# Access Compliance Report

## Public Rights-of-Way

### (Curb Ramps)

Intersection ID: 48135	Main Street: HIGHLAND_CREEK_PY	Cross Street: SQUIRREL_TRAIL_LN	Location: NE
ADA ID: E90A6B6C97A4	Ramp Type: Perp	Initial Pass/Fail: Fail	Overall Compliance: No
		Severity Score: 8.75

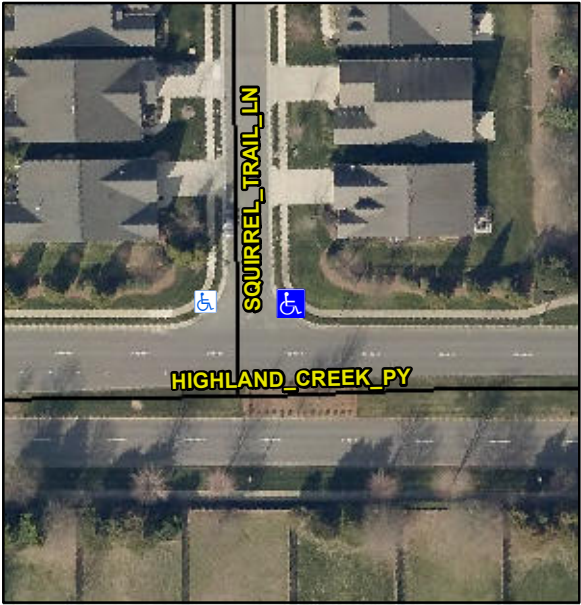
Codes/Mitigation Info/Possible Solution			Field Measurements/Component Compliance			
	Possible Solutions:		<b>Compliance</b>	<b>Description</b>	<b>Data</b>	
	<b>Remove &amp; Replace Entire Ramp.</b>		<b>N/A</b>	Ramp Length (in)	<b>47.5</b>	<b>Yes</b>
			<b>No</b>	Ramp Width (in)	<b>47.0</b>	<b>Yes</b>
			<b>N/A</b>	Flare Type LT	<b>N/A</b>	<b>N/A</b>
			<b>N/A</b>	Flare Slope LT (%)	<b>N/A</b>	<b>N/A</b>
			<b>N/A</b>	Flare Traversable LT?	<b>N/A</b>	<b>N/A</b>
			<b>N/A</b>	Landing Length (in)	<b>N/A</b>	<b>N/A</b>
			<b>N/A</b>	Landing Width (in)	<b>N/A</b>	<b>N/A</b>
			<b>N/A</b>	Landing Slope (%)	<b>N/A</b>	<b>N/A</b>
			<b>N/A</b>	Landing X Slope (%)	<b>N/A</b>	<b>N/A</b>
			<b>N/A</b>	Landing Curb? (Y/N)	<b>N/A</b>	<b>N/A</b>
			<b>N/A</b>	Shared Landing?	<b>N/A</b>	
			<b>N/A</b>	Gutter Ponding?	<b>N/A</b>	<b>N/A</b>
			<b>N/A</b>	Gutter Lip Ht (in)	<b>N/A</b>	<b>N/A</b>
			<b>N/A</b>	Painted X Walk1?	<b>No</b>	<b>N/A</b>

X Walk 1 Direction	<b>To W</b>	<b>N/A</b>
			<b>N/A</b>	X Walk 1 Width (in)	<b>N/A</b>	<b>N/A</b>
				X Walk 1 Slope (%)	<b>2.4</b>	<b>N/A</b>
				X Walk 1 X Slope (%)	<b>0.9</b>	<b>N/A</b>
			<b>N/A</b>	Ramp inside XWalk1?	<b>N/A</b>	<b>N/A</b>
<p>Surveyor Notes:</p> <p><b>N/A</b></p> <p>PROW/ADA:</p> <p><b>Not Found, R304.5.1</b></p>			<b>N/A</b>	Road Slope (%)	<b>N/A</b>	<b>N/A</b>
			<b>N/A</b>	Road X Slope (%)	<b>N/A</b>	<b>N/A</b>
			<b>N/A</b>	Any Obstructions?	<b>N/A</b>	<b>N/A</b>
				Obstruction Type		
					<b>N/A</b>	<b>N/A</b>
			<b>Yes</b>	Surface Condition? (G/P)	<b>Good</b>	
Total Cost:		\$ 1850.00
